Change Order #4 Dicker Road

Project: Dicker Road
Contract: C-19-017-11-05
Project #: STP 1902(323) MM
CSJ: 0921-02-312
Limits: Spur 115 (23rd Street) to FM 2061 (Jackson Road)

CONSTRUCTION CONTRACT CHANGE ORDER NUMBER: 4

CO #4 - Reduce Structural
 Excavation(SPL)

TYPICAL STORM SEWER PIPE BEDDING & BACKFILL DETAIL
 THE PIPE GRAVEL BEDDING, TO BE PAID UNDER ITEM 400 STRUCT EXCAV (SPECIAL) THE NONWOVEN GEOTEXTILE IS NOT A PAID ITEM SHOULD BE SUBSIDIARY TO ITEM 464.

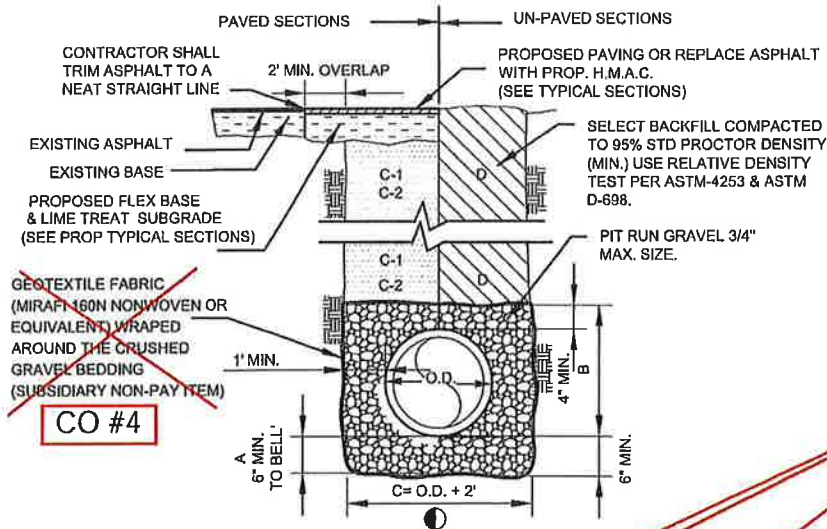
- A. GRAVEL BEDDING PLACED BEFORE PIPE IS LAID UP TO BELL OF PIPE (MIN. THICKNESS = 6") PIT RUN GRAVEL 3/4" MAX. SIZE.
- ~~B. GRAVEL PLACED AFTER PIPE IS LAID FROM BOTTOM OF PIPE TO 4" ABOVE THE TOP OF PIPE. PIT RUN GRAVEL 3/4" MAX. SIZE.~~

- ~~C-2. (STATE MAINTAINED ROADWAYS) COMPACTED CEMENT STABILIZED BACK FILL WITH 7% PORTLAND CEMENT COMPACTED AS PER ASTM D-4253 AND ASTM D-698. PAID UNDER ITEM 400 CEMENT STABL. BACKFILL.~~

Remove geotextile fabric from around trenches. Place geotextile around box culvert joints. RCP has pipe gaskets, not requiring geotextile. Remove cement stabilized backfill from RCP requirements. Shown as subsidiary under the cut & restore details.

DICKER ROAD
MISCELLANEOUS
DRAINAGE DETAILS

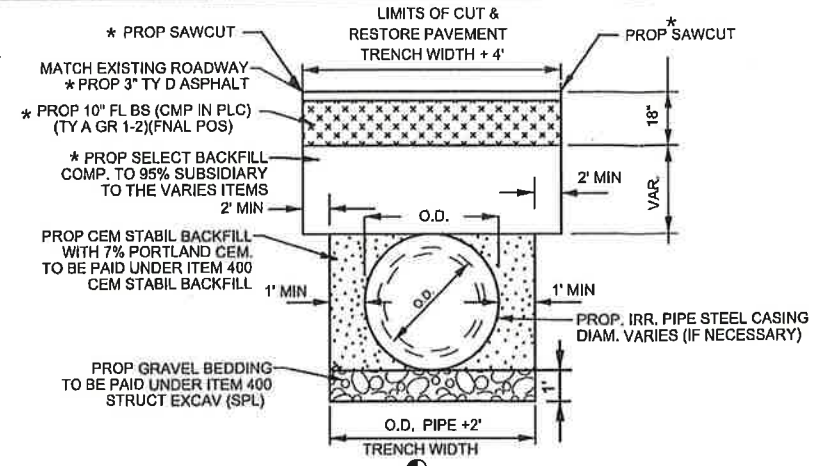
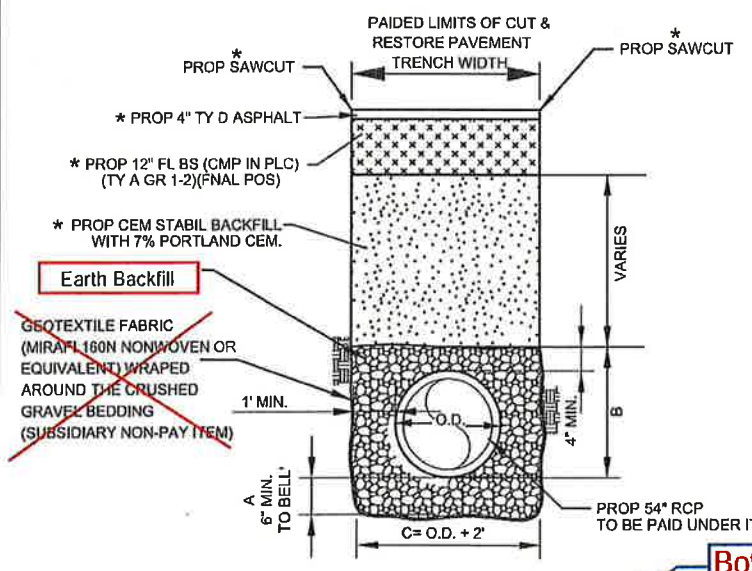
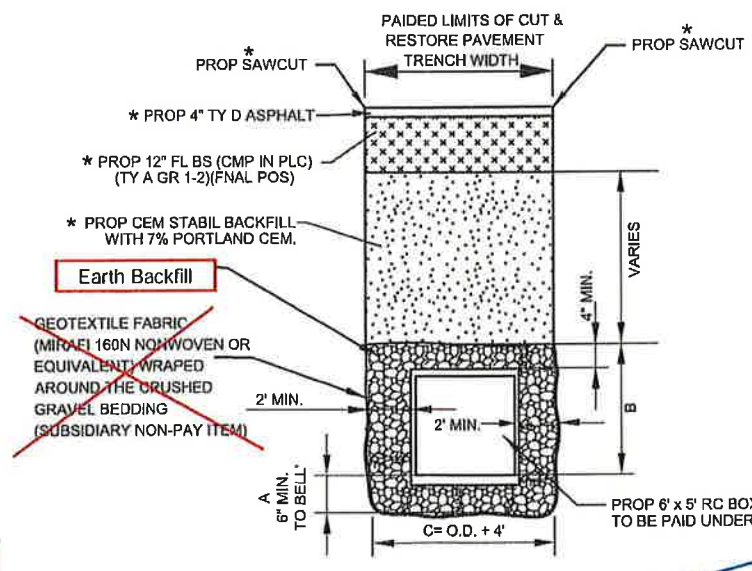
CO #4
Remove geotextile fabric from around trenches. Place geotextile around box culvert joints. RCP has pipe gaskets, not requiring geotextile. Remove cement stabilized backfill from RCP requirements. Shown as subsidiary under the cut & restore details.
